## CORRESPONDENCE

### Comments on “Estimation of Tropical Cyclone Wind Hazard for Darwin: Comparison with Two Other Locations and the Australian Wind-Loading Code”

Cook and Nicholls recently argued in this journal that the city of Darwin (Northern Territory), Australia, should be located in wind region D rather than in the current region C in the Australian/New Zealand Standard AS/NZS 1170.2 wind actions standard, in which region D has significantly higher risk. These comments critically examine the methods used by Cook and Nicholls and find serious flaws in them, sufficient to invalidate their conclusions. Specific flaws include 1) invalid assumptions in their analysis method, including that cyclones are assumed to be at the maximum intensity along their entire path across the sampling circle even after they have crossed extensive land areas; 2) a lack of verification that the simulated cyclone tracks are consistent with the known climatological data and in particular that the annual rate of simulated cyclones at each station greatly exceeds the numbers recorded for the entire Australian region; and 3) the apparent omission of key cyclones when comparing the risk at Darwin with

FIG. 1. Recorded maximum gusts exceeding  $15 \text{ m s}^{-1}$  from individual tropical cyclones at (a) Darwin Airport during 1960–2005 and (b) Port Hedland Airport during 1958–2004. The abscissa is the index number of each event but is labeled with the year of occurrence.

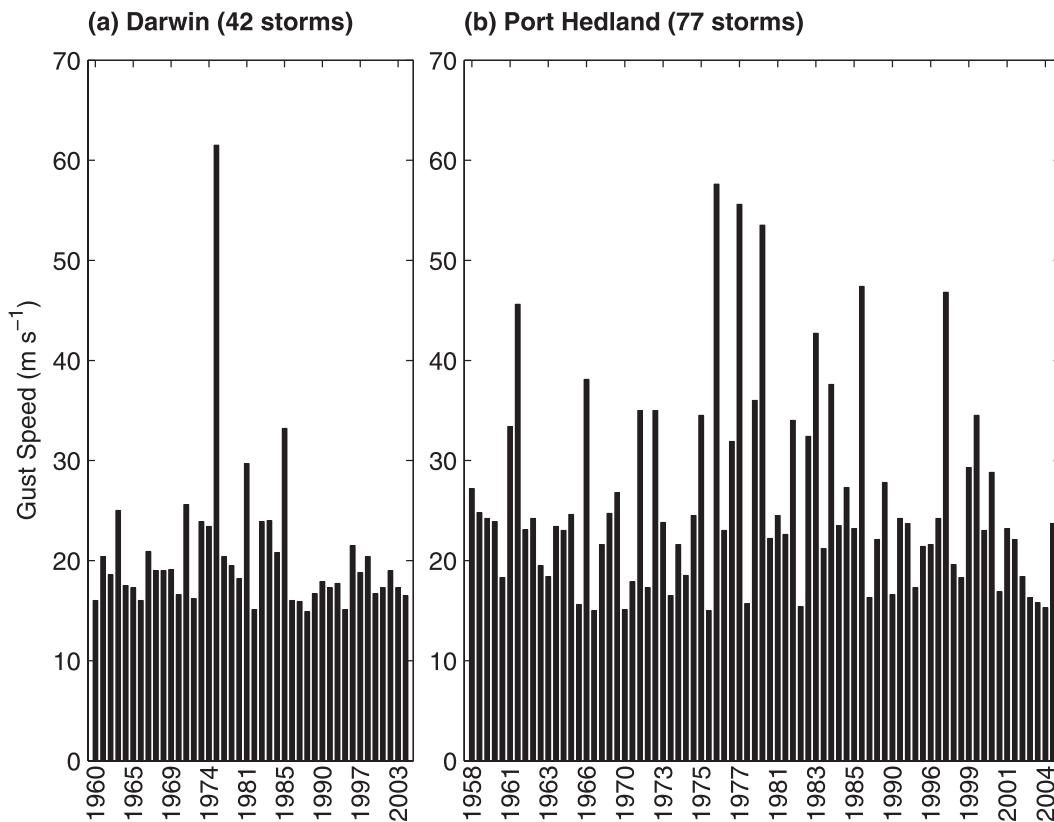
Figure 1 shows the recorded peak gusts during each of the tropical cyclones that produced gusts of  $15 \text{ m s}^{-1}$  or more at Darwin and Port Hedland Airports, from the periods of 1960–2005 and 1958–2004, respectively. These values and the cyclone names for the Darwin data are listed in Table 1. The two anemometers have broadly similar exposure, anemometer types, and record duration. Although the anemometer type and recording method have changed with time, these changes have occurred at similar times and so it is reasonable to compare the two records. Even a casual inspection of these figures gives ample reason to doubt CN09’s assertion that the risk is similar at these two locations.

FIG. 2. Analysis of tropical cyclone maximum wind gusts observed at Port Hedland Airport and Darwin Airport in comparison with AS/NZ 1170.2 (2002) regional wind speeds.

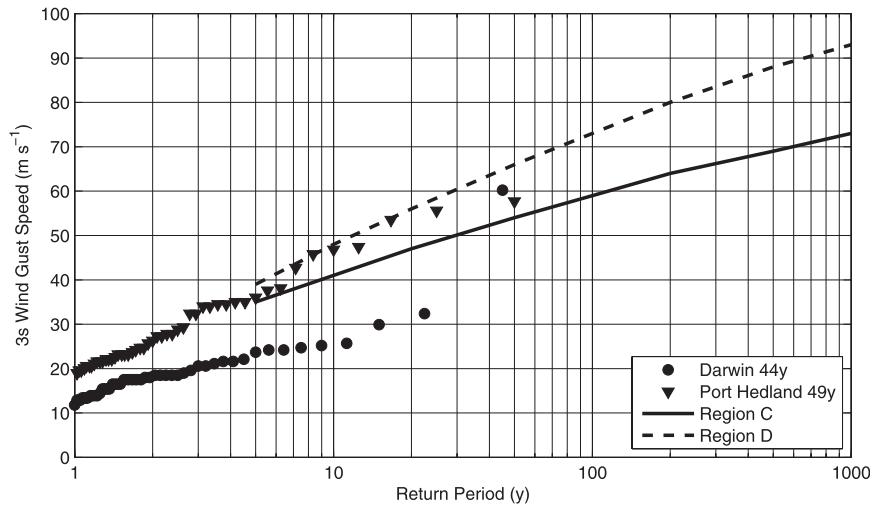
The line for Port Hedland in CN09's Fig. 3 shows return periods of about 30 and 15 yr for gust speeds of 50 and  $40 \text{ m s}^{-1}$ , respectively. Our Fig. 2 indicates return periods of about one-half of these values for those wind speeds, however. Those values are consistent with our Fig. 1b, which indicates three crossings of  $50 \text{ m s}^{-1}$  in 46 years of record and seven crossings of  $40 \text{ m s}^{-1}$  in the same period. This result throws doubt on the consistency of the simulated data for Port Hedland with respect to

FIG. 3. Return period for cyclones within (a) 100 and (b) 200 km of Port Hedland (inverted triangles), Darwin (circles), and Townsville (triangles) that exceeded the given intensity, as measured by central pressure, during 1970–2007 (black) and 1985–2007 (gray), according to the historical record.

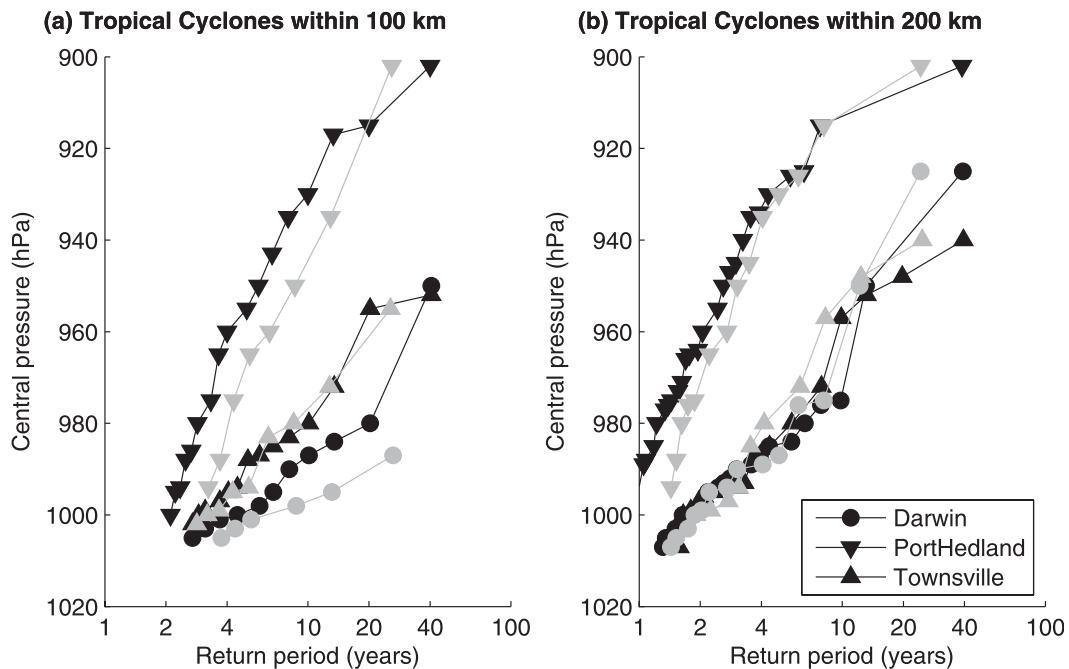
A further indication of greater intense tropical cyclone activity at Port Hedland than at the other locations is provided by the central pressures in the historical record. Figure 3 displays the return period for cyclones exceeding a certain intensity (as measured by the estimated central pressure), within radii of 100 and

slightly lower risk on this metric for storms within a radius of 100 km but not for storms within 200 km, for which the curves essentially coincide. Both panels show that Port Hedland has much shorter return periods at all intensities than do the other two locations and hence has higher risk of a storm occurrence within the given radius. These conclusions apply whether data from 1970 to 2007 (black curves) or from 1985 to 2007 (gray curves) are used, albeit with some quantitative differences that may

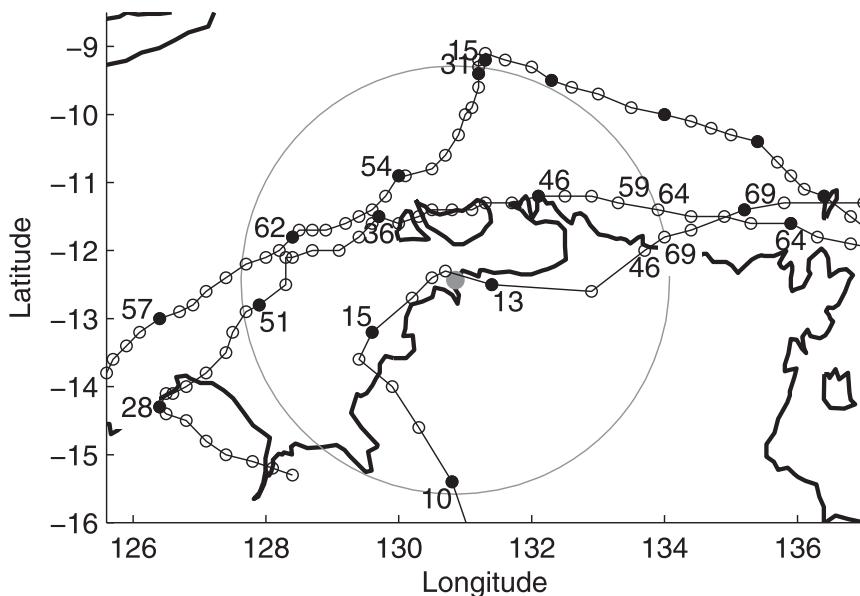
Assumptions 1 and 2 are demonstrably false and have the effect of greatly increasing the estimated risk. For example, Fig. 4 shows the best-track estimated tracks and intensities (maximum 10-min mean wind at 10-m height) of Tropical Cyclones Thelma, Ingrid, and Monica. It is clear from Fig. 4 that the cyclone intensity varies significantly along the tracks. A major cause of such variation is landfall, leading to an immediate drop in the surface winds that is due to increased friction and a longer-term decay that is due to the loss of the oceanic heat source. The intensities ranged from 31 to 62, from 31 to 59, and from 10 to 69  $\text{m s}^{-1}$  for the three cyclones while within the 350-km circle centered on Darwin used by CN09. Hence their first assumption, that of constant intensity, is invalid but will clearly inflate the estimated risk. The second assumption fails because it does not take into account the effect of land. Tracks over land will inevitably

be less intense than those over sea—indeed, this is the main reason that Tropical Cyclone (TC) Monica rapidly weakened as it approached Darwin. CN09’s method not only neglects the weakening of Monica but also assumes that storms identical to Thelma and Ingrid but displaced southward over land are as likely as the real Thelma and Ingrid. In reality, such a displacement would result in a substantially reduced intensity. The third assumption means that the winds from “near misses,” in which the location is close to the storm but is not within the radius to maximum winds, are not considered in determining the return period for these winds, which will have the effect of making the return-period curve too steep at lower wind speeds.

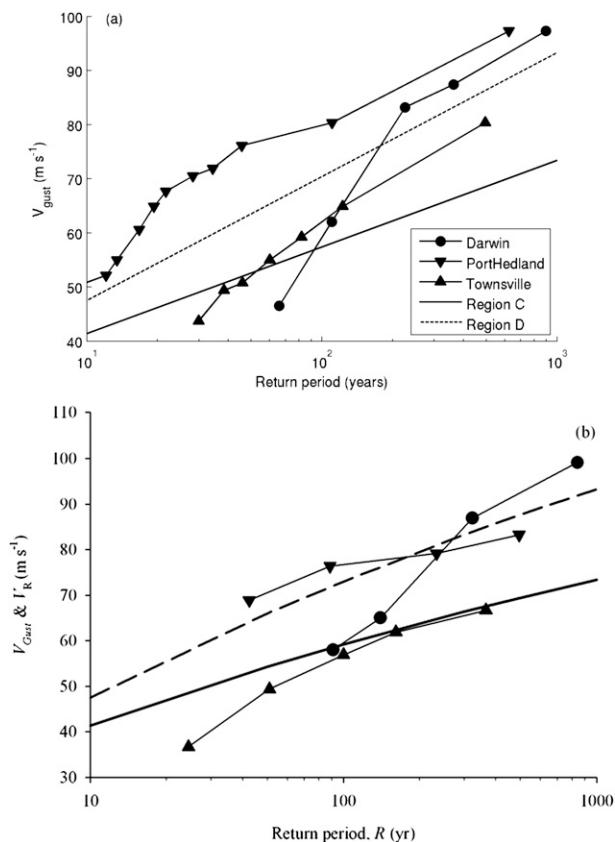
- 1) The curve for Darwin (circles) is similar to that in CN09, but those for Port Hedland (inverted triangles) and Townsville (triangles) are substantially above the corresponding curves in CN09.
- 2) The curve for Darwin is below that for Port Hedland at all return periods and below that for Townsville at short return periods.
- 3) The highest point on the curve for Port Hedland corresponds to TC Orson (Table 3), whereas that for

In comparing our Fig. 5a with CN09’s Fig. 4b, it is apparent that their curves for Port Hedland and Townsville are missing (at least) the contribution of severe TCs Orson and Larry, respectively. Note that we use the same version of the best-track database as CN09 specified. They do not list the storms used for their calculations, and therefore it is unclear why these differences arise. On their page 2335, they note that “[a]llowance was made for the weakening from the

maximum wind speed values to landfall values,” although without giving further details. Possibly this adjustment could account for the discrepancy between our Fig. 5a and their Fig. 4b with the Port Hedland and Townsville curves, but, if so, it is then unclear why they did not make a similar adjustment to the Darwin data.

The presentation of these calculations should not be regarded as being in any way an endorsement of CN09’s calculations of return periods. As noted above, their technique includes assumptions that inflate the risk and overestimate the slope of the return-period curve, consistent with the fact that the curves in our Fig. 5a lie well above the lines from the wind code at the higher wind speeds but have a steeper slope at lower wind speeds. Rather, the purpose is to demonstrate that CN09 have incorrectly applied their technique by apparently omitting the most severe storm(s) to have affected Port Hedland and Townsville, but not Darwin. The good match between the return periods for Port Hedland and region D, and Townsville and region C, in CN09’s Fig. 4b should not be interpreted as implying that their method is valid for those locations. Rather, that agreement arose because of CN09’s apparent neglect of some very significant storms in those regions. When those storms are included, the mismatch with the wind code provides further cause to doubt the validity of their method.
